Final Environmental Impact Report

Cordoba Center Project

SCH# 2016122022

April 2019

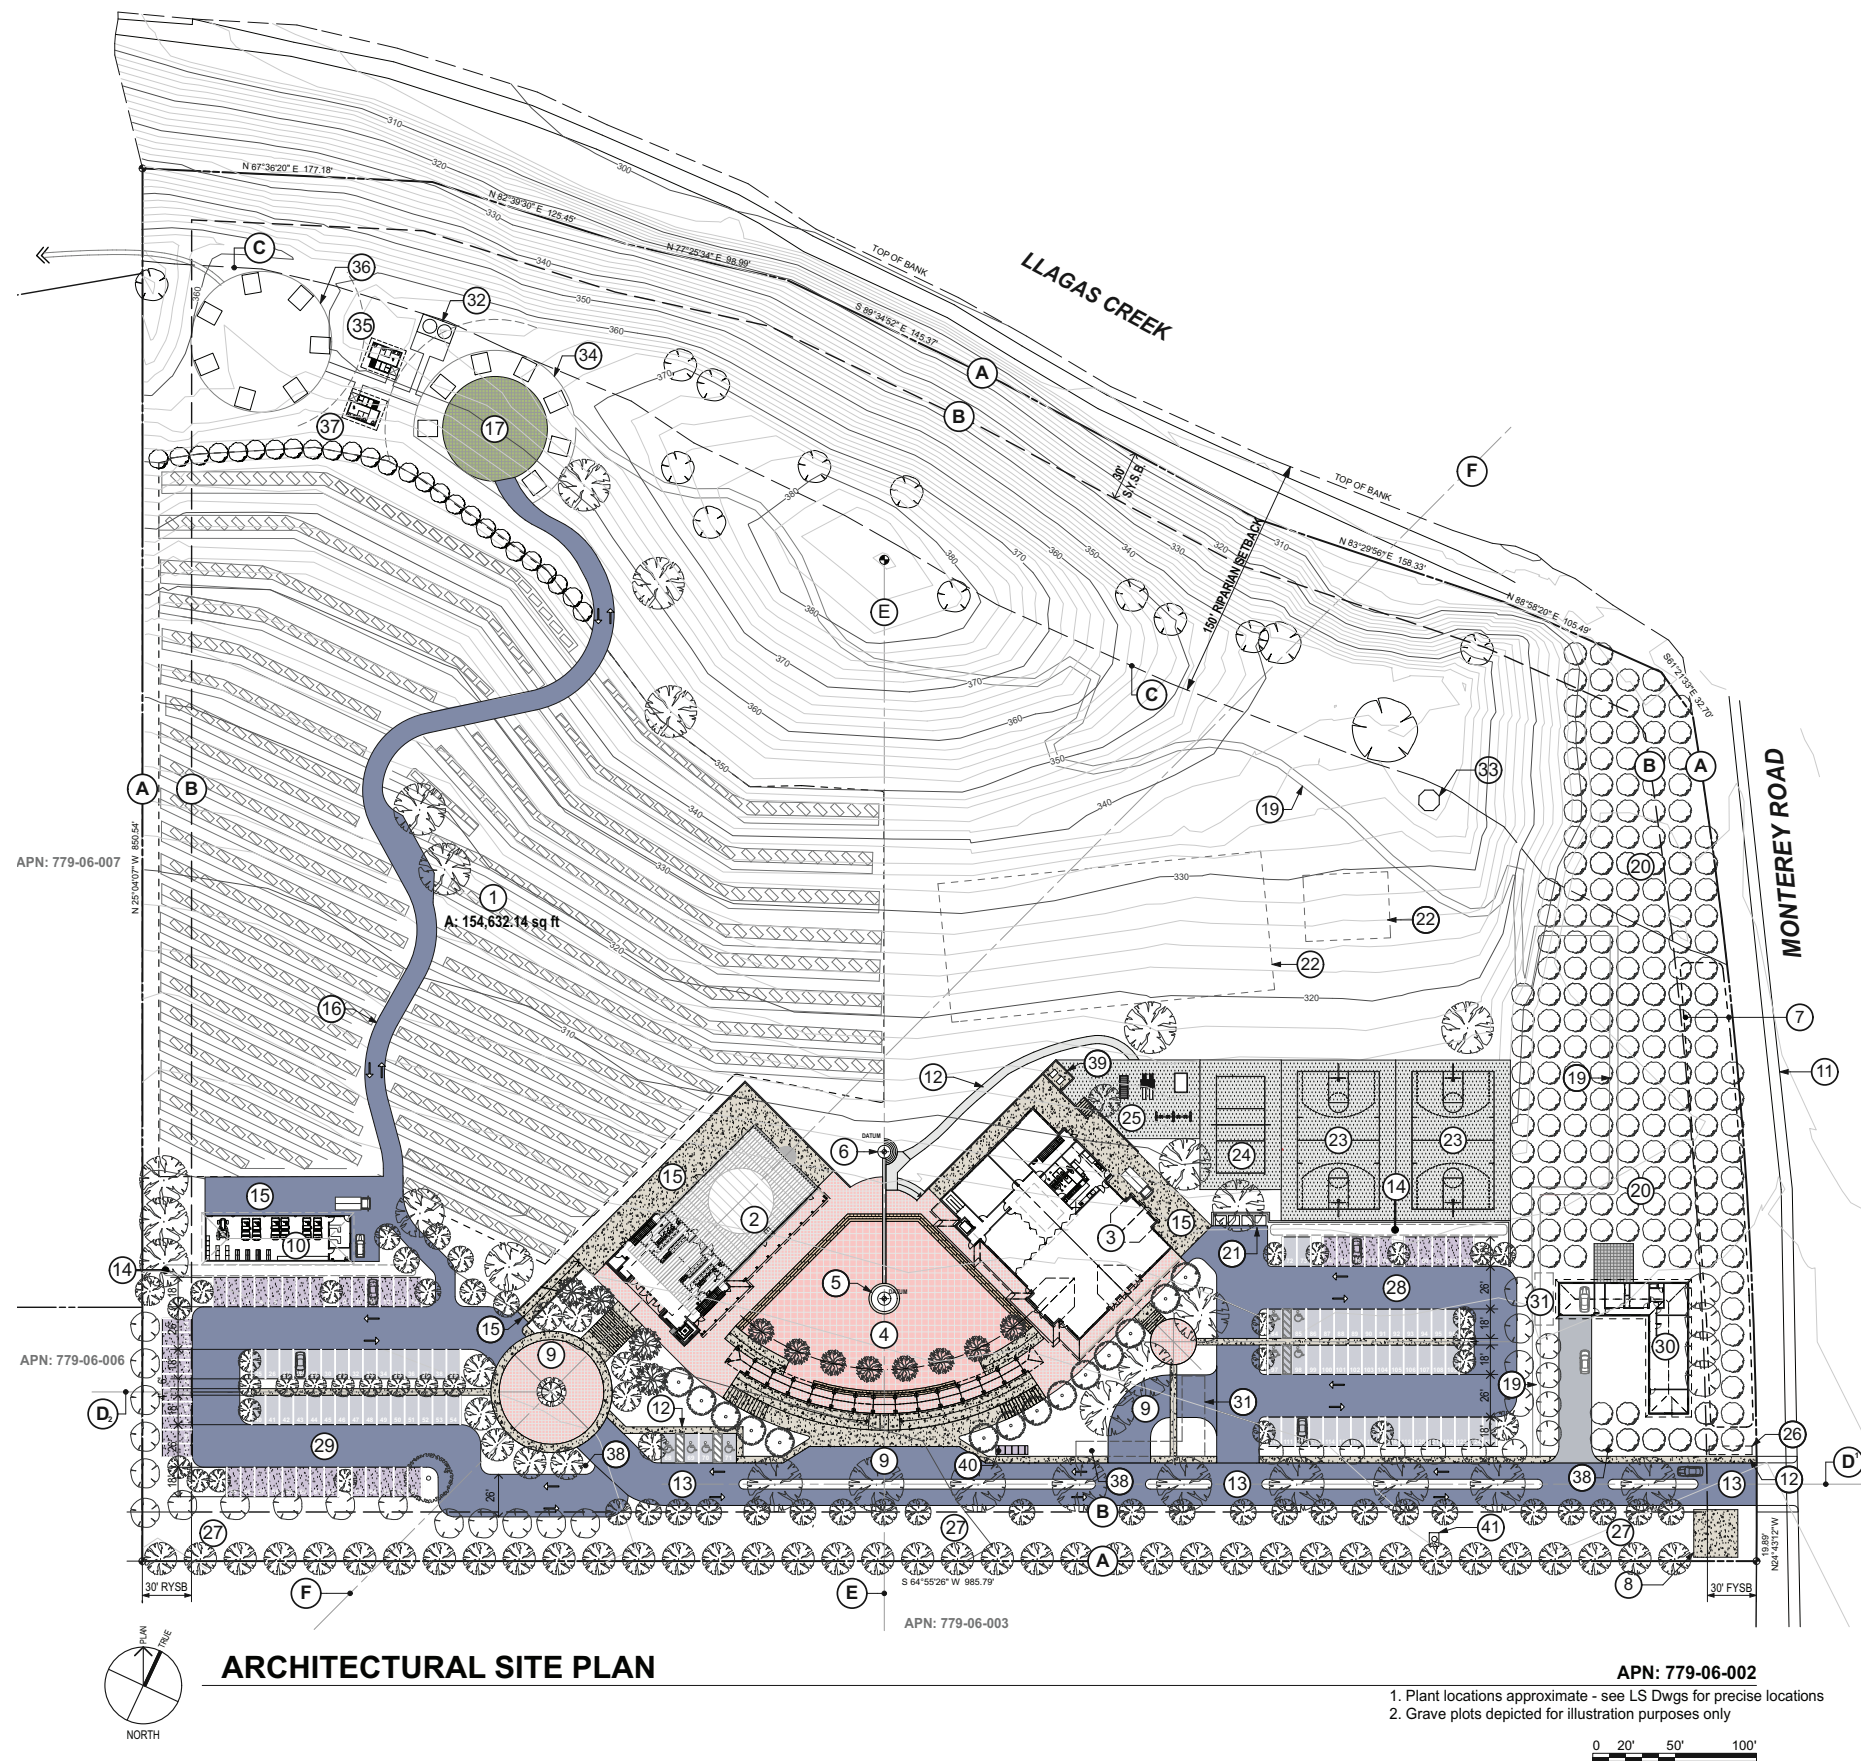
Section and Page	Text Revisions
Section 4.6.4 – Page 4.6-8	<p>The bullets under Impact 4.6-3 (p. 4.6-8) is REVISED as follows:</p> <ul style="list-style-type: none"> • The existing median is inadequate to support northbound vehicles to turn left at the proposed driveway location. In addition, left turns out of the project driveway cannot be made safely due to the curvature of the road and its significant width. • Right turns into the project driveway by southbound traffic can be accommodated; however, deceleration in the right-hand travel lane could impede following vehicles traveling at the speed limit. • Right turns from the project site could be accommodated. However, vehicles turning right from the proposed driveway would enter the travel lane at a lower speed than southbound vehicles moving at posted or higher speeds. This situation could potentially be exacerbated if drivers are unable to assess when it is safe to exit the site as a result of inadequate sight distance of oncoming traffic or because of obstructions to visibility, due to required landscaping. • Northbound vehicles, when turning right onto Monterey Road, could potentially make a U-turn at California Avenue to travel north if a U-turn pocket is created out of the existing median. While there is adequate room to accommodate a U-turn pocket at California Avenue for north bound traffic, the length of this lane has not been evaluated.

Section and Page	Text Revisions
	approaching vehicle on Monterey Road, and the location where the two vehicles would intersect).
	<ul style="list-style-type: none"> ➤ The project applicant shall construct a deceleration lane on the southbound side of Monterey Road leading to the project driveway. ➤ The project applicant shall construct, an acceleration lane on the southbound side Monterey Road leading from project driveway. ➤ <u>The project driveway/entrance shall be designed to allow only right-in, right-out operation from and to Monterey Road. The applicant shall submit the project driveway/entrance design to the County Department of Roads and Airports for review and approval prior to issuance of any grading or building permits. The project applicant shall submit a queuing analysis to determine the length of the left turn pocket at California Avenue needed to accommodate the number of northbound vehicles exiting the project site during peak hours. The applicant shall construct this improvement.</u> ➤ A stop sign shall be required where the driveway intersects with Monterey Road.

Implementation of Mitigation Measure 4.6-3 would avoid risks of traffic hazards that are conceivable based on current concept plans. At the project driveway, installing landscaping with an appropriate setback would avoid interfering with the existing sight triangle, so driver response time would be adequate and potential hazards to motorists would be avoided. Adding a deceleration lane for southbound traffic turning into the site would also avoid a potential traffic hazard caused by vehicles slowing abruptly to enter the project. This deceleration lane would allow vehicles to transition from the southbound through traffic travel lanes to a turning lane and slow safely in preparation for a right turn into the project driveway. This reduces the chance of southbound through-moving vehicles needing to slow and queue behind turning vehicles. Similarly, an acceleration lane would allow exiting traffic to merge safely with the oncoming southbound traffic. Adding an adequate left turn pocket at California Avenue would allow U-turns, which allows right in, right out only operation at the project driveway. Limiting the turning movements from and to the project driveway to right-in and right-out turns from and to Monterey Road would avoid traffic hazards associated with left-hand turns from and to the site. Facility users would be able to make U-turns south of the facility at E. San Martin Avenue. The stop sign at the project driveway would slow traffic leaving the site and would reduce potential traffic hazards. With the implementation of Mitigation

Map 1a: Drainage Route from CCP California Ave. to Highland Ave.

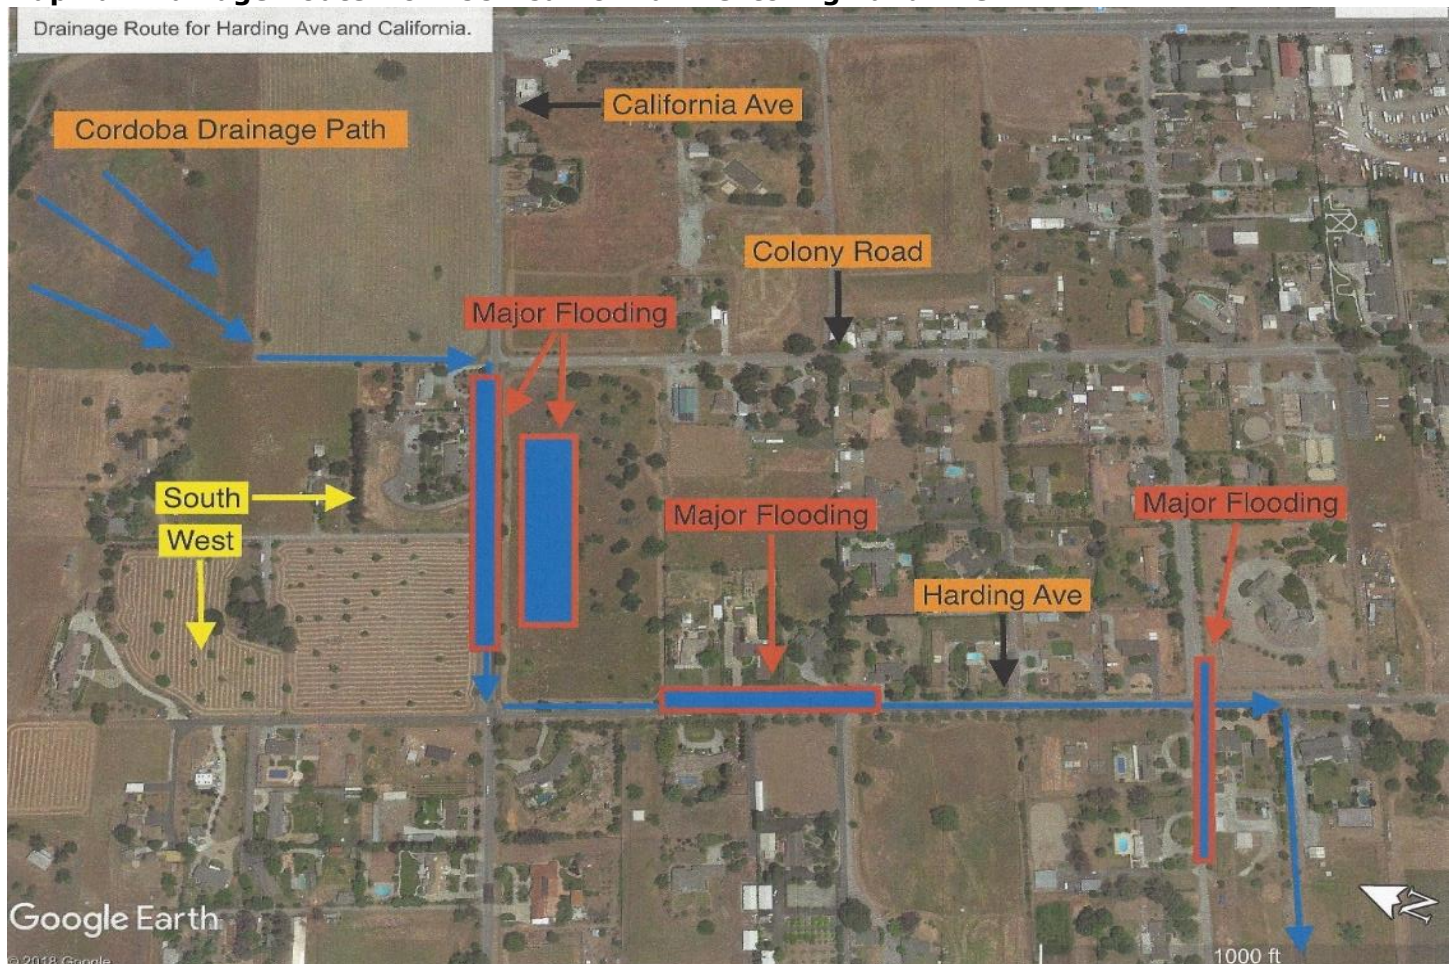
- Documentation over the last 10-20 years from Roads & Airports Department showing the number of times flooding issues/repairs have occurred at California, Colony, Harding, & Highland Avenues.

- 5-SMNA-45: Taking into consideration the property's orientation in relation to the contours shown on Exhibit 4.1-1 of the Draft EIR, it is accurate to say the onsite storm water sheet-flows to the south-southwest. It should be noted that other, less sloped properties are located between the project site and California, Colony, and Harding Avenues. Therefore, it is possible sheet-flows change direction as they cross these properties or when flows reach the drainage swale along California Avenue. At any rate, the project's proposed drainage system would capture any additional runoff from project development. No change would occur to the existing drainage condition at California, Colony, and Harding Avenues as a result of implementation of the proposed project.

Map 1b – CCP Proposal includes list of impervious material used.

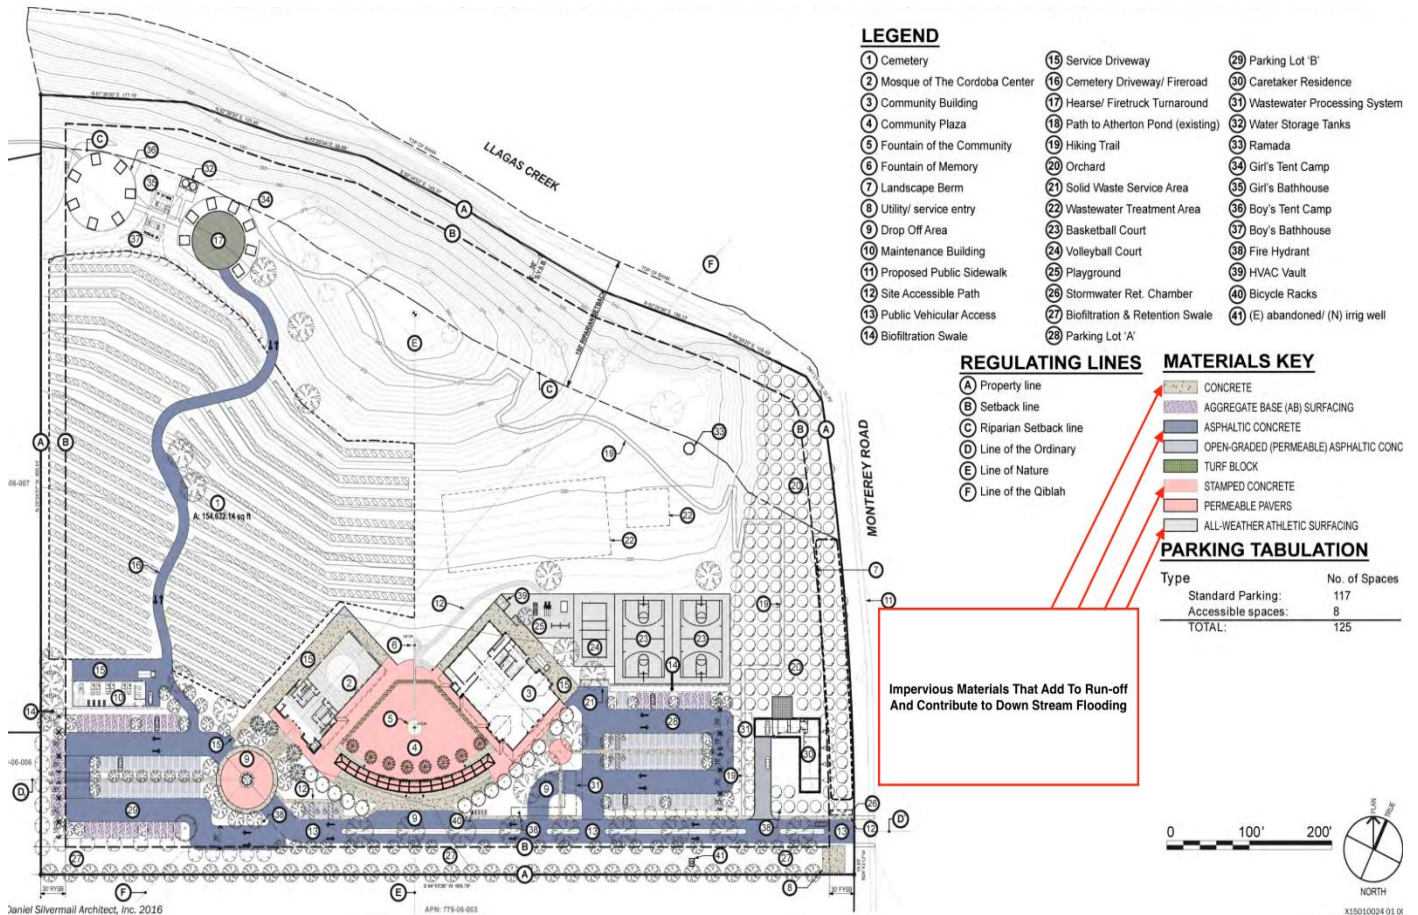
² Map 1b: CCP Proposal includes list of impervious material used.

Photo 1a – Drainage Path looking South of CCP

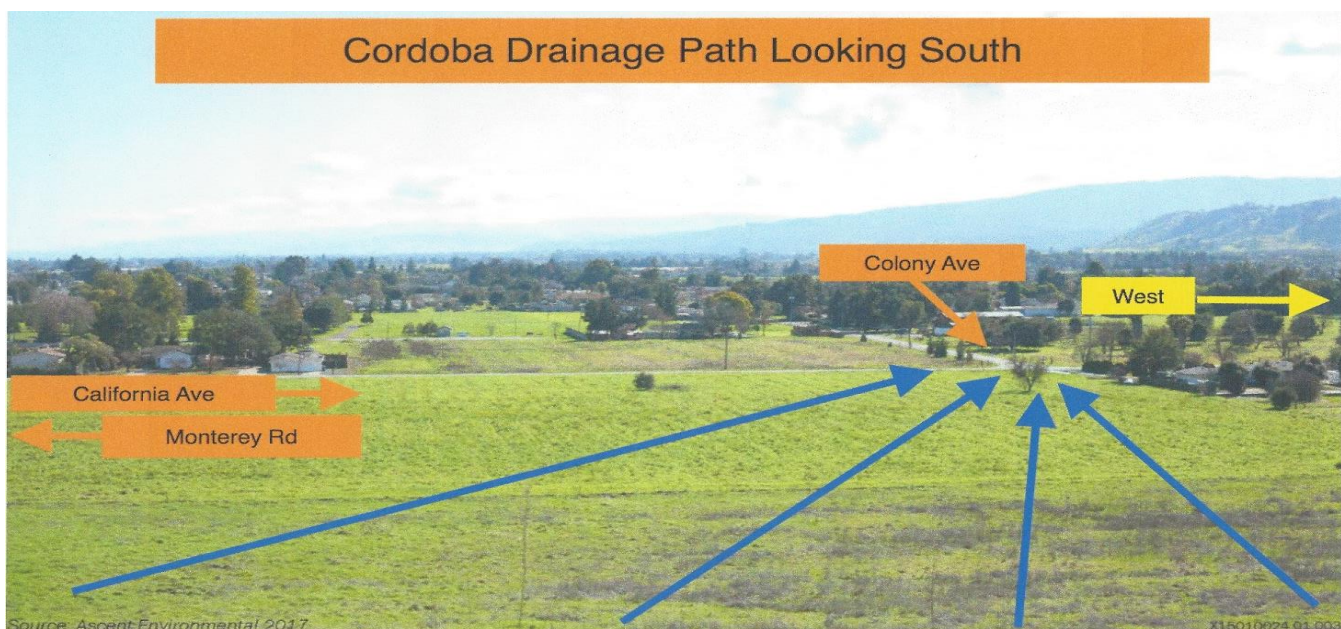
The DEIR shows the studies and percolation tests between 2006 and 2015 and confirm that the soils on the **west-southwest** side of the CCP have slow percolation rates. This would create an increase of run-off and drainage coming from the CCP hillsides. There is concern about the amount of the impervious surface areas the CCP proposes. In review of the DEIR Table 3-1 on the Proposed Land Uses and Project Site Coverage, we note the calculated NEW impervious surface area potential to be 104,800 sq. ft. SMNA would ask that the DEIR:

Photo 1b – Flood waters at California Ave. and Colony Ave. before heading south.

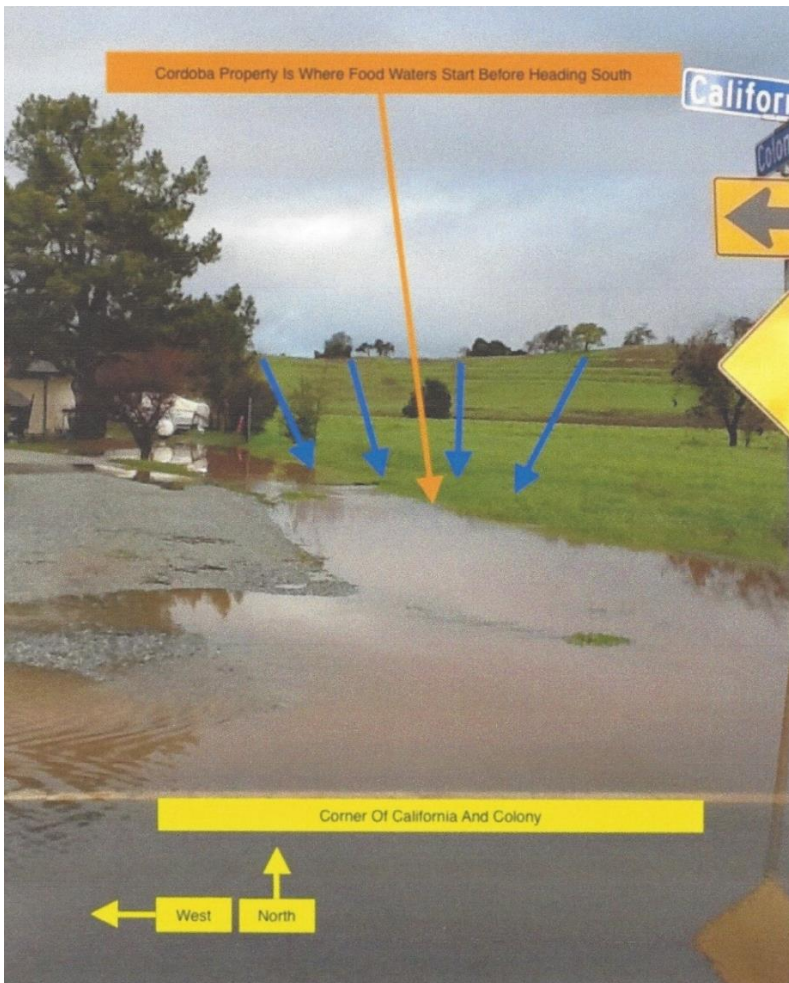
While we recognize that the property itself is not in a FEMA flood zone, the geography and hills of the CCP location does appear to contribute to watersheds that overwhelm and flood neighborhoods downstream.³

FIGURE 3.3-1

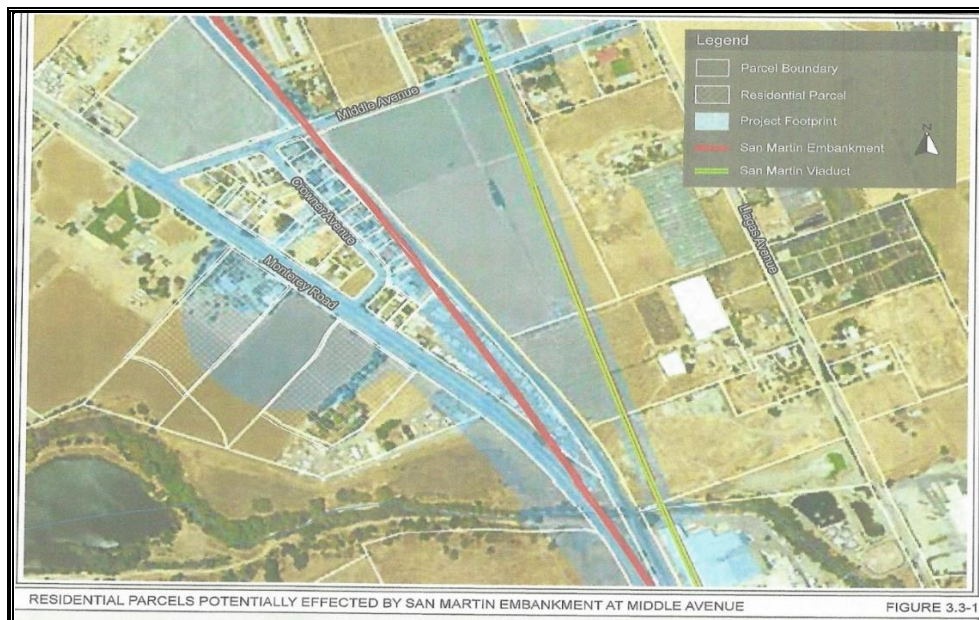
According to Figure 3.3-1 and Table 2.2-2 of the County of Santa Clara May 2017 Constraints Analysis of HSR Alternatives, the HSR "Project Footprint" will extend west onto about 200 feet of the CCP site, which will significantly impact numerous facilities, such as: 53

The Cumulative Impact 4.5.5: Contribution to cumulative short-term construction generated noise, states that *“the closest HSR alternative would be located over 1,400 feet east of the nearest sensitive receptor.”* This is incorrect as shown on Figure 3.3-1 which we include and was prepared by Santa Clara County. According to the DEIR graphics, the HSR will be anywhere from 120 feet to 500 feet away from various proposed buildings of the CCP. The distances could be considerably reduced depending on the curvature and speed design of the HSR tracks across Llagas Creek and the relocation of Monterey Road to the west. The SMNA Board is of the opinion:

The Cumulative Impact 4.4-6: Contribution to cumulative long-term operational noise levels, states that, *“the two identified HSR alignments...are both located over 1,400 feet from the sensitive receptors closest to the proposed project.”* Again, this is incorrect as noted earlier and as shown on the attached County of Santa Clara Figure 3.3-1 with the main facilities of the CCP all within 600 feet of the **ONLY** proposed HSR alignment. The SMNA Board requests the DEIR:

- Section 4.6.3. should state there is **ONLY one proposed alignment alternative being considered by HSR and that it does impact the CCP site**. This alignment will probably require relocation of Monterey Road to the west onto the CCP site to reduce the curvature of the HSR track across Llagas Creek for the required speed of the HSR. (See attached Figure 3.3-1 from the 2017 County of Santa Clara Constraints Analysis High Speed Rail Alternative Summary.)
